ADDENDUM E-1

September 1, 2026

Chippewa Downs Grandstand
Belcourt, North Dakota
Project #26028

PRAIRIE ENGINEERING, P.C.
1905 17TH ST SE
MINOT, NORTH DAKOTA

1 POWER PLAN
1/8" = 1'

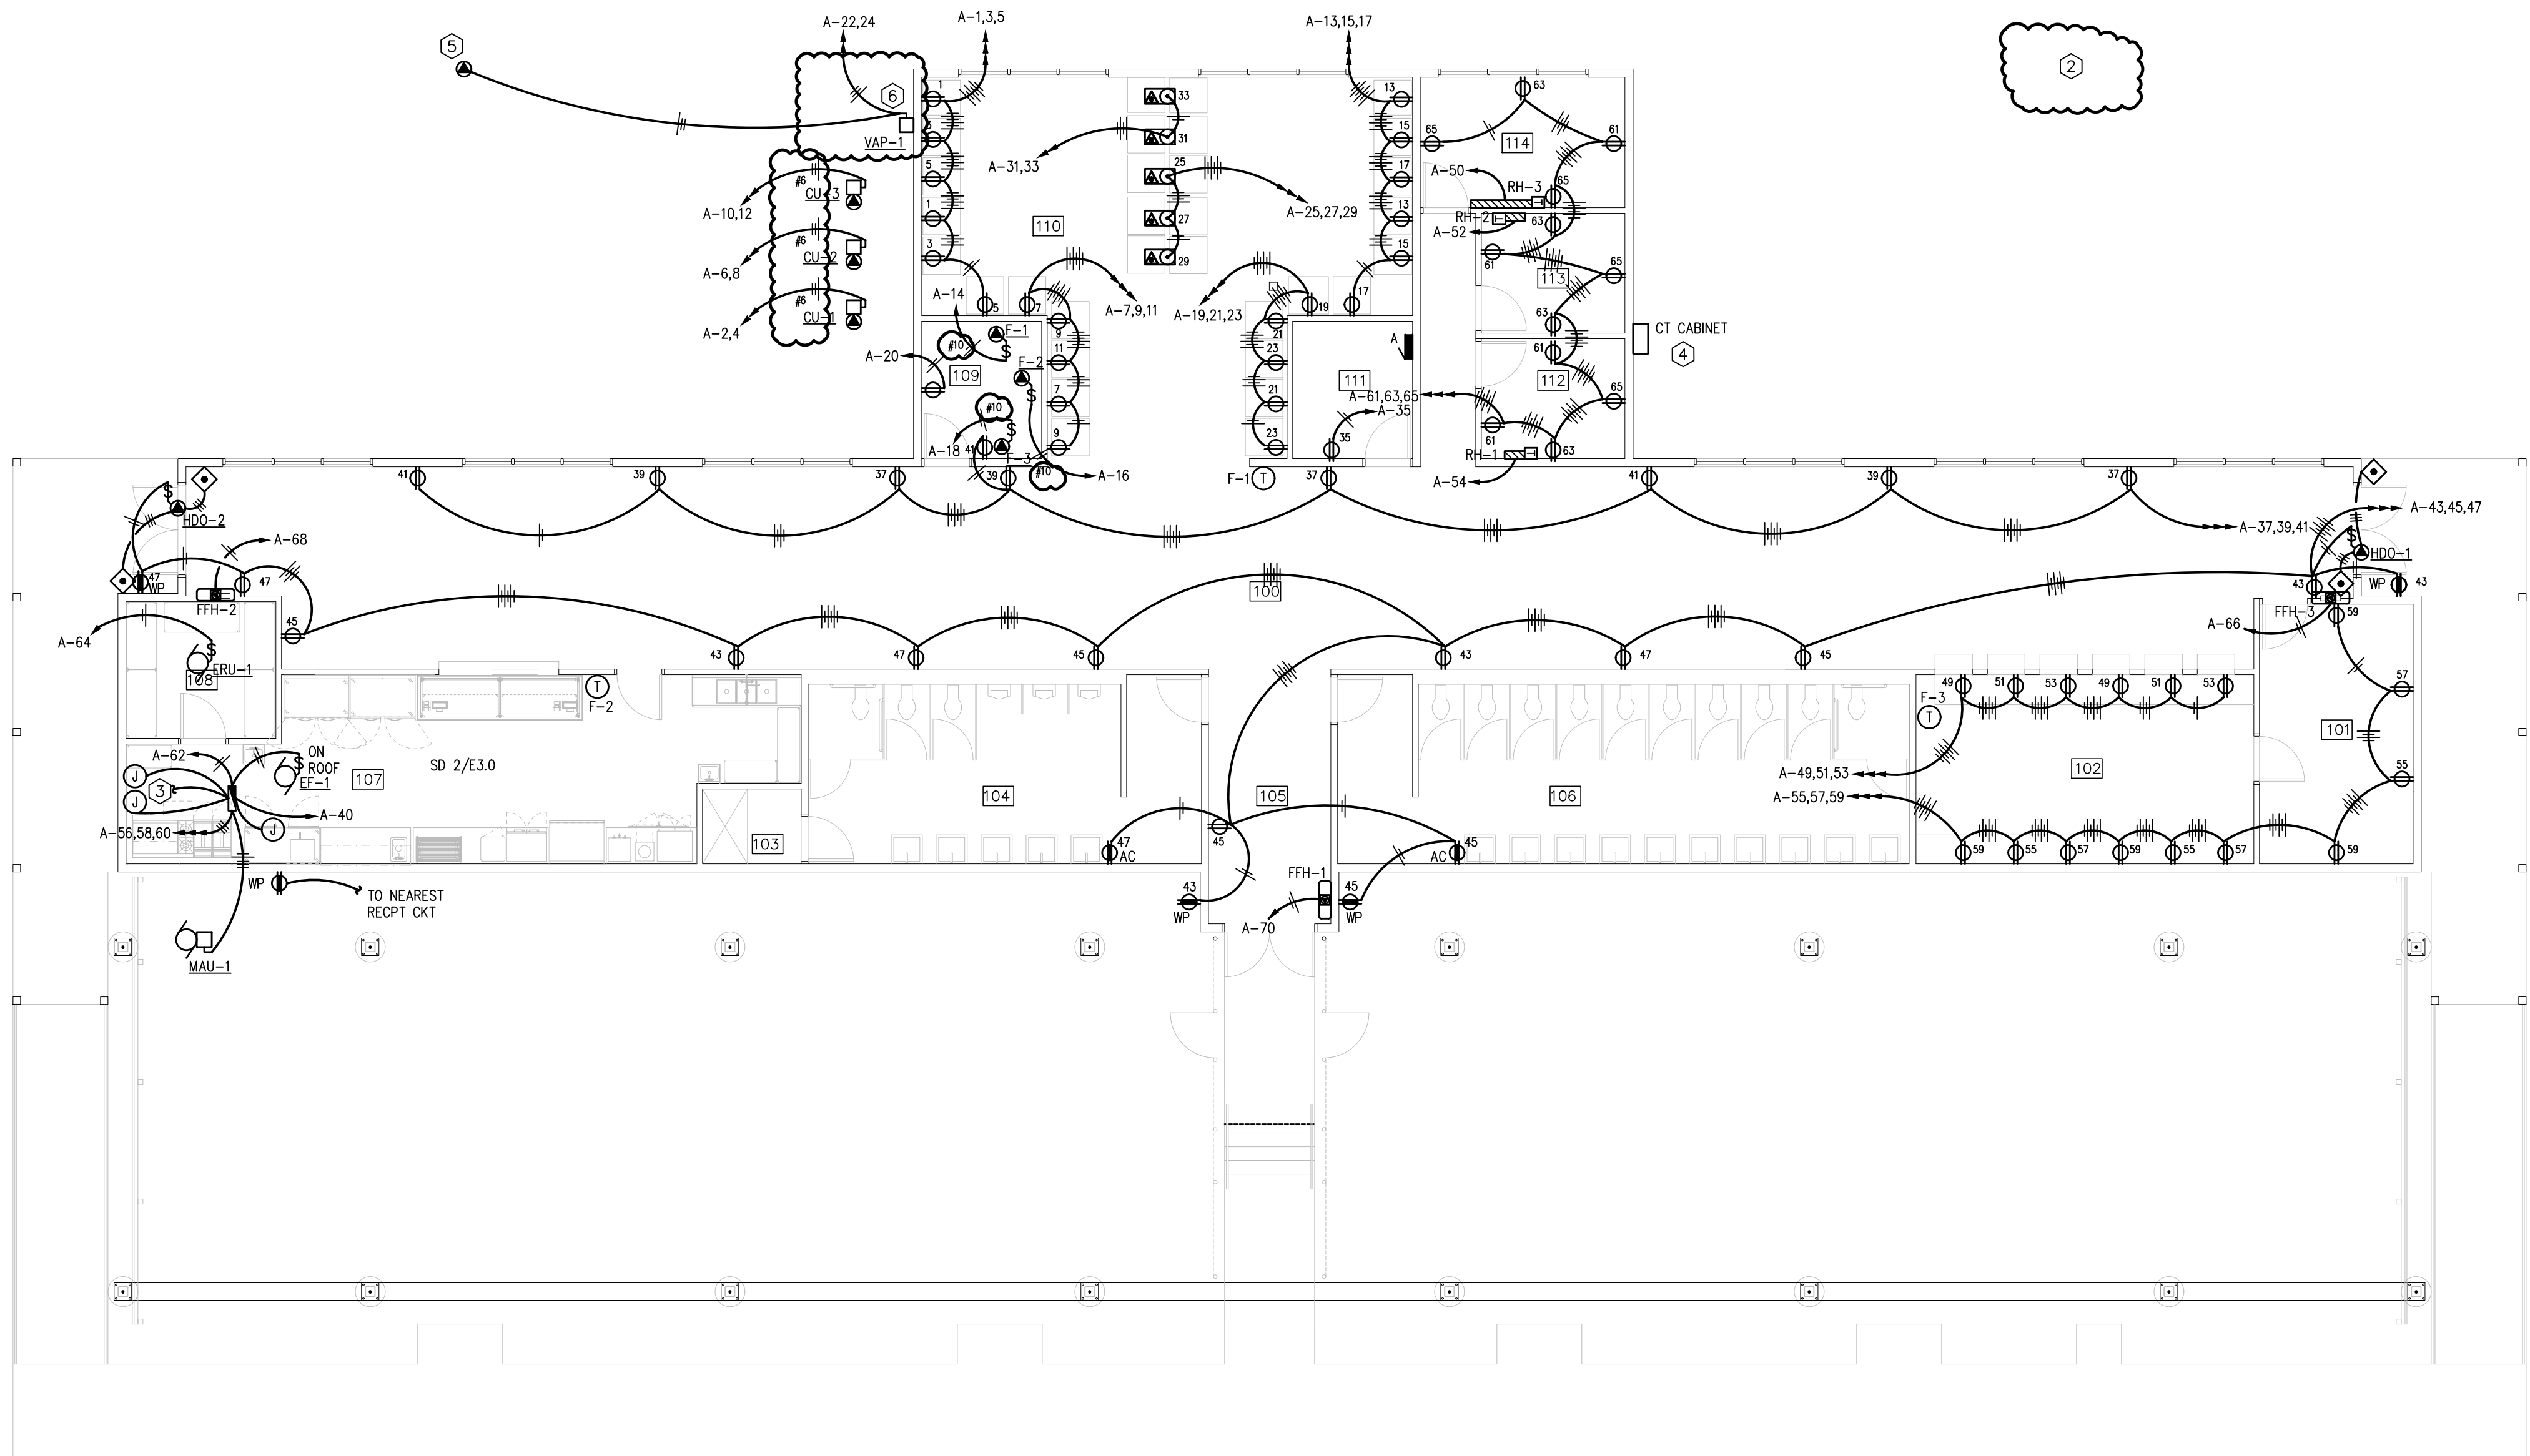
DRAWING ITEM #3. Detail 1/E3.0

- A. Updated wire sizing for furnaces and condensing units.
- B. Added approximate location for Keynote 2.
- C. Added Keynote 5.

1
E4.0
SYSTEMS PLAN
1/8" = 1'
N

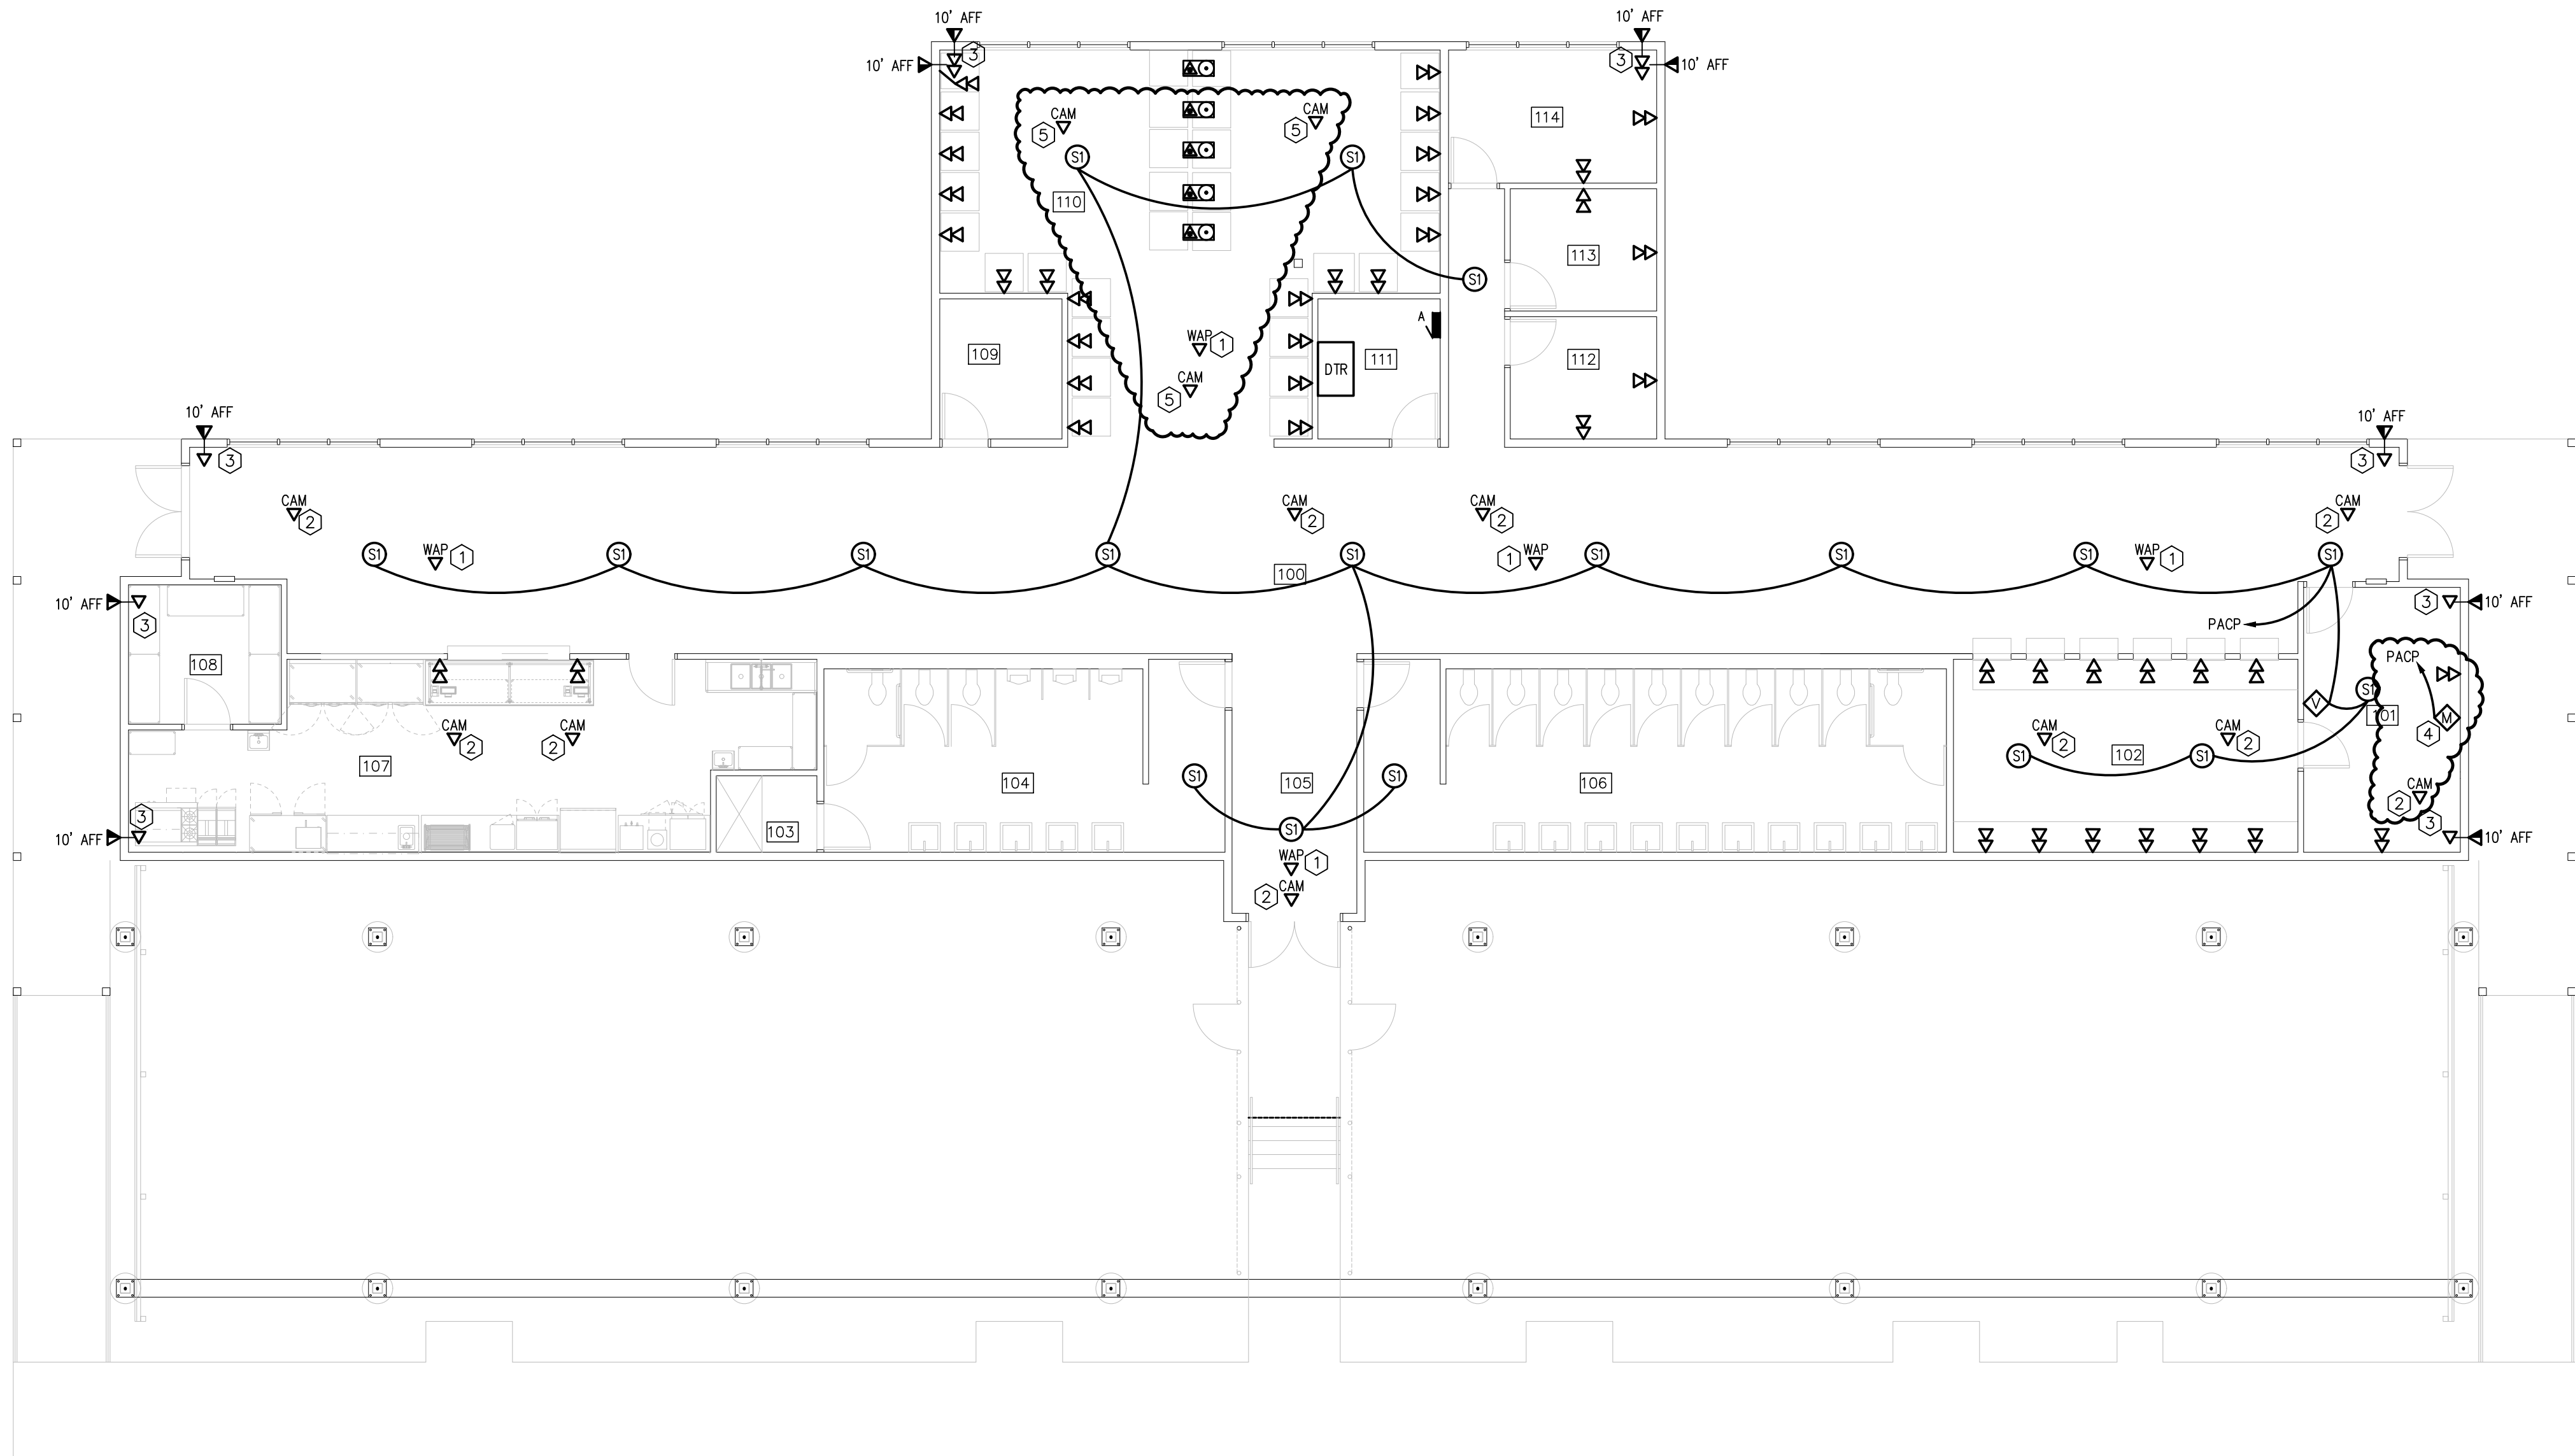
DRAWING ITEM #4. Detail 1/E4.0

- A. Added Keynote 5 for cameras in the slot room.
- B. Added microphone input and camera location in the office room #101.

2
E5.0
ENLARGED PRESS BOX PLAN
1/4" = 1'
N

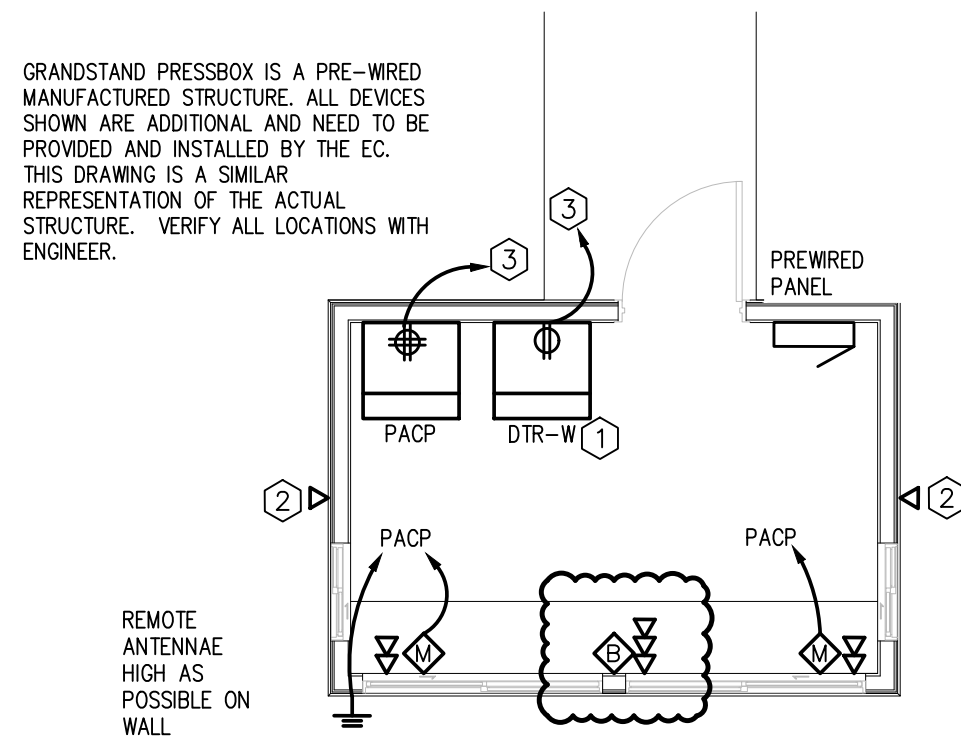
DRAWING ITEM #6. Detail 2/E5.0

- A. Added three data jacks in the press box.
